**ADDENDUM TO PROPOSAL DOCUMENT(S)**

**ADDENDUM NUMBER:** #1      **DATE OF ISSUANCE:** 2/20/2020      **PAGE NUMBER:** 1 of 5

**PROPOSAL NUMBER & TITLE:** 20-094P Design Central Landfill Warm Storage Addition

**FOUNDATION PLAN**  
SCALE 1/8" = 1'-0"

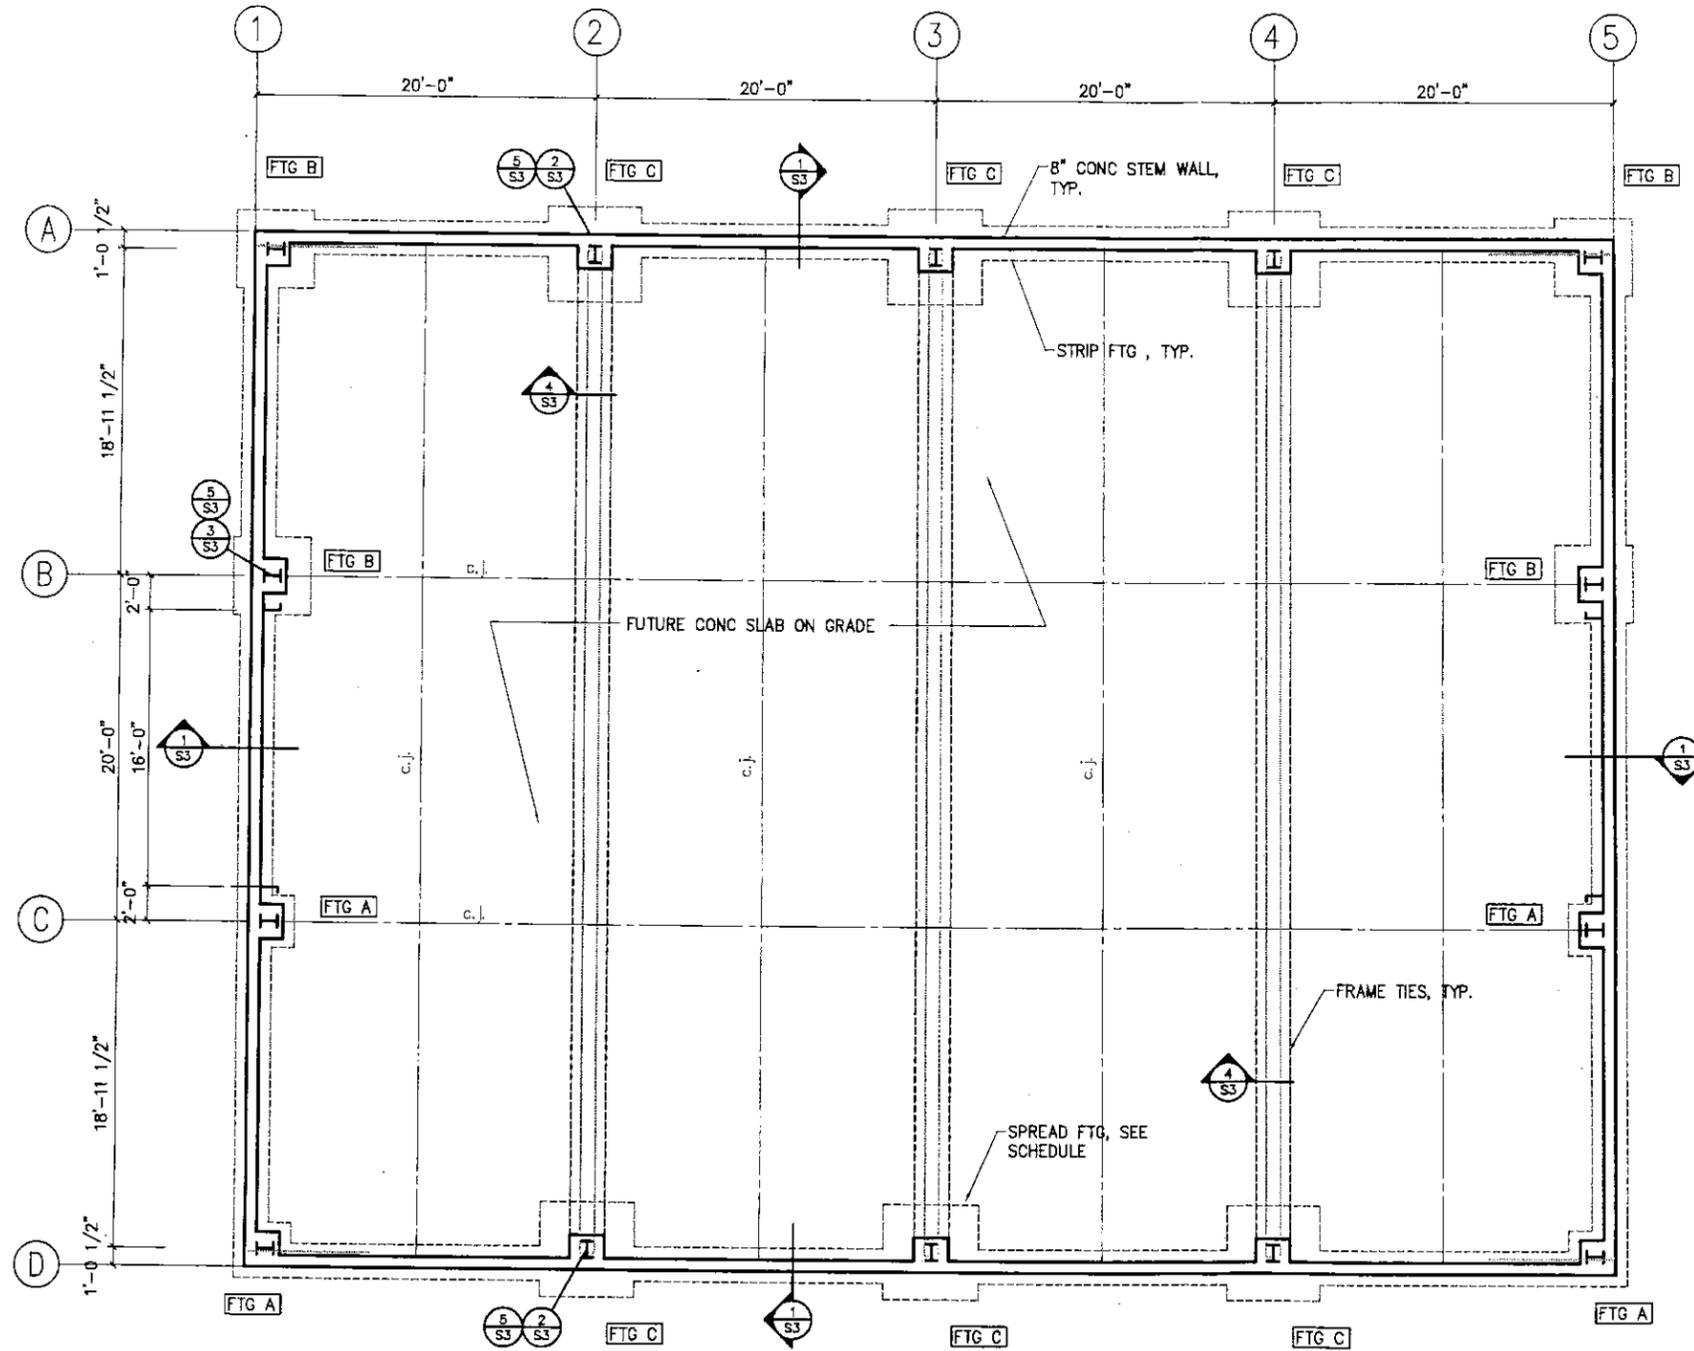
- Q: What is the existing building foundation type  
A: See attachment #1 to this addendum for foundation drawings.
